**Roseau West Interceptor
and
Wetland Restoration Project**
(RRWD Project Number 2003-1)

April 30, 2004

Re: Advisory Review of Revised West Interceptor Preliminary Engineering Report

DIRECTOR'S ADVISORY REPORT; REVISED WEST INTERCEPTOR PRELIMINARY ENGINEERING REPORT

Figure 14. Outlet Structure

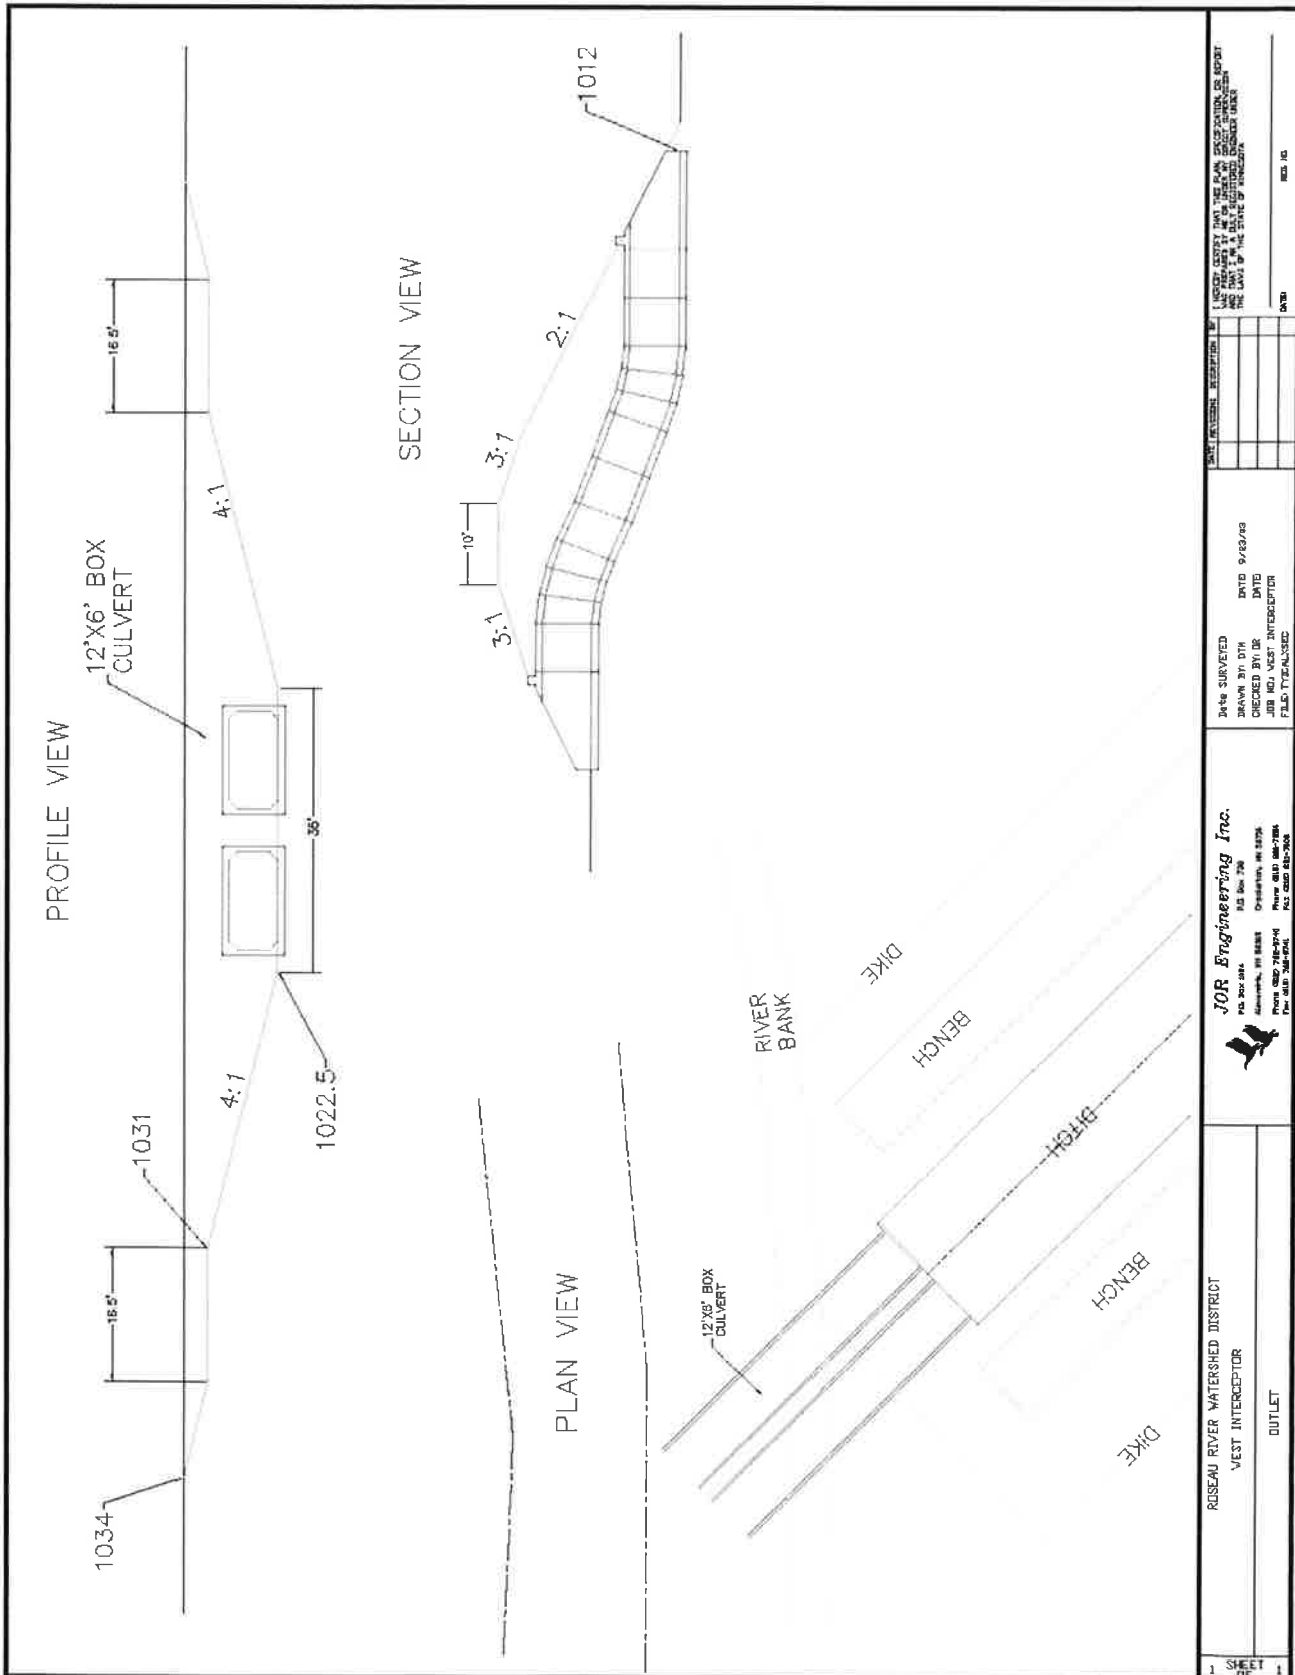
Figure 13. Outlet Structure and associated report text: It's not clear if the intent for the broken-back design is to custom cast the conduit sections, or depend on incremental flexure at joints of standard sections to achieve the desired profile. If the latter is intended, I wonder if the resulting pressure on joints might cause breakage of the joints, particularly if there is differential settlement. Although I don't have experience with the proposed design, I'd also expect construction of the desired profile to be difficult. Might a cast in place concrete drop structure, or weir, with an armored stilling basin, be more reliable and reasonably cost-effective? Is a deeper and steeper channel, without a drop structure at the end, less cost-effective? The current design doesn't indicate any erosion control at the outlets of the proposed conduits, which could jeopardize the end sections via erosion.

Figure 15. Replacement Farmland Drainage

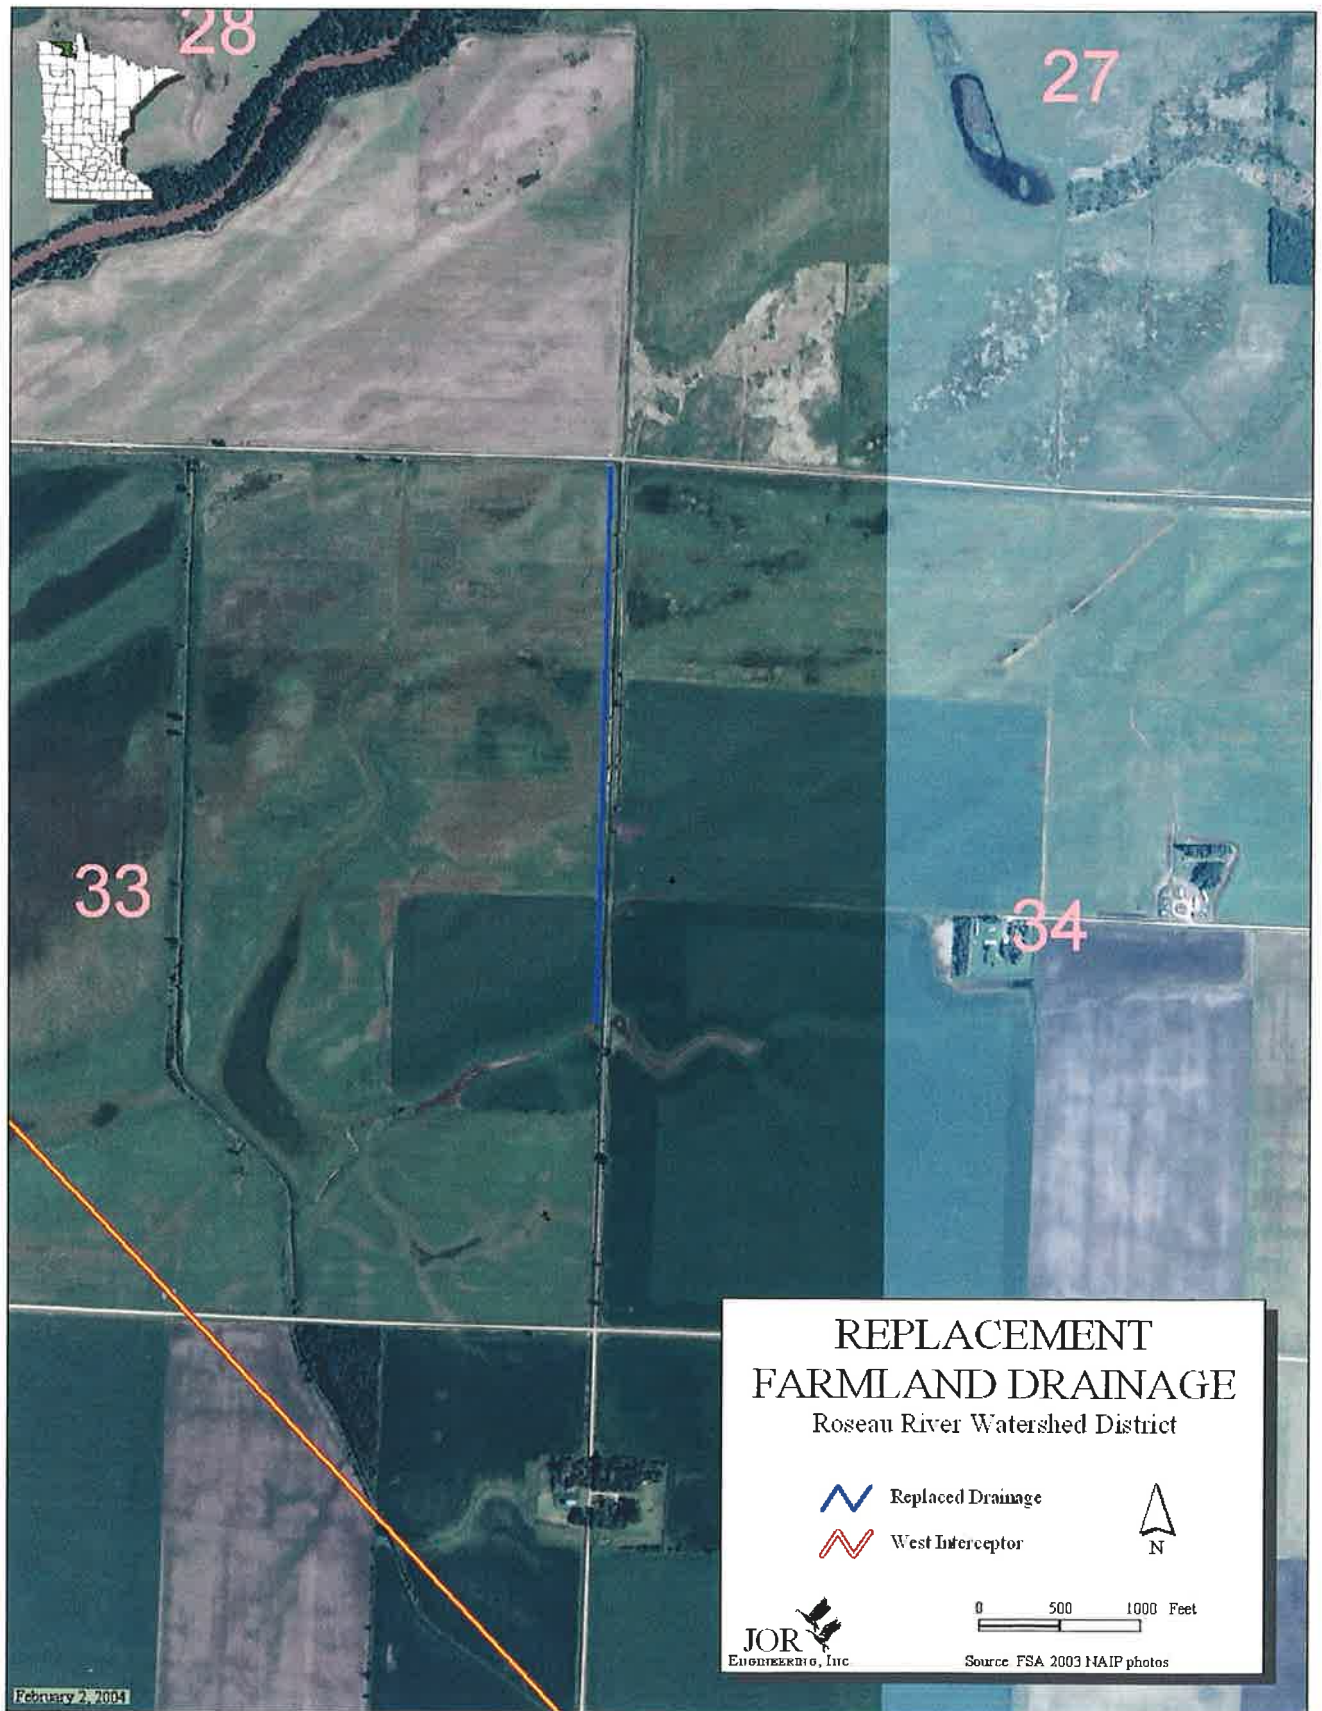
Figure 2. Route of Proposed Interceptor Channel, and Figure 14. Replacement of Farmland Drainage: The proposed channel alignment crosses an existing drainage ditch twice in Section 4, T162N, R40W. It's not clear how the drainage in the existing ditch will be handled. Might it be best to realign the interceptor channel somewhat to avoid crossing the existing drainage ditch?
